SB-10033266-9031

Measure no.	Subject	
US 22898888-02	Clutch does not open fully on G650X models with Rotax engine	
Status date (mm/dd/yy) 11/24/09	Status Accepted	PQM Problem reference
Date created (mm/dd/yy) 11/24/09	Created by Carsten Gruetzmacher	Organization US, MOT
Release date (mm/dd/yy)	Approved by	Dealer release Allow automatic release

Picture 1

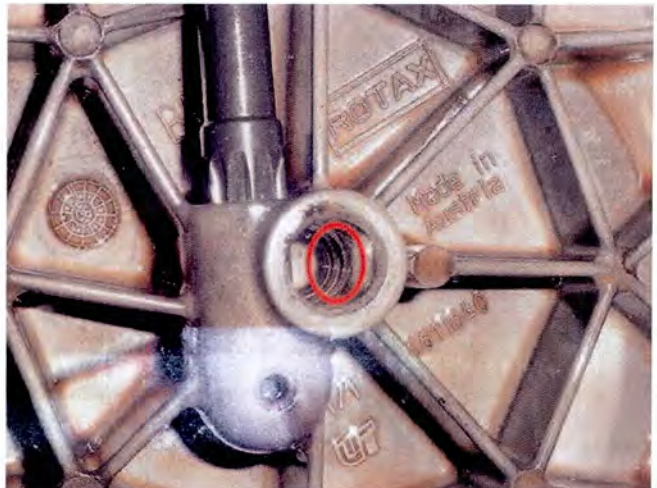
G650X models with ROTAX engines may display the following symptoms after approx. 6,000 mi. on the clock:

- The clutch does not open fully
- In some cases, the clutch lever cannot be pulled as far as the handle; the clutch control is stiff

Wear to release bearing guide (see picture 1 below) in the ROTAX clutch housing cover (see picture 2 below).

Installation of LONCIN clutch housing cover 11 14 7 700 331 in conjunction with new release bearing 21 21 7 709 526. In the LONCIN clutch housing cover, the release bearing is supported in a cast iron bush, unlike the Rotax clutch housing cover.

CAUTION: The part numbers of the removed ROTAX parts must be entered in the warranty claim:

Rotax cover: 11 14 7 699 289 / Rotax release bearing: 21 21 7 709 526 / Rotax actuating shaft: 21 21 7 682 692
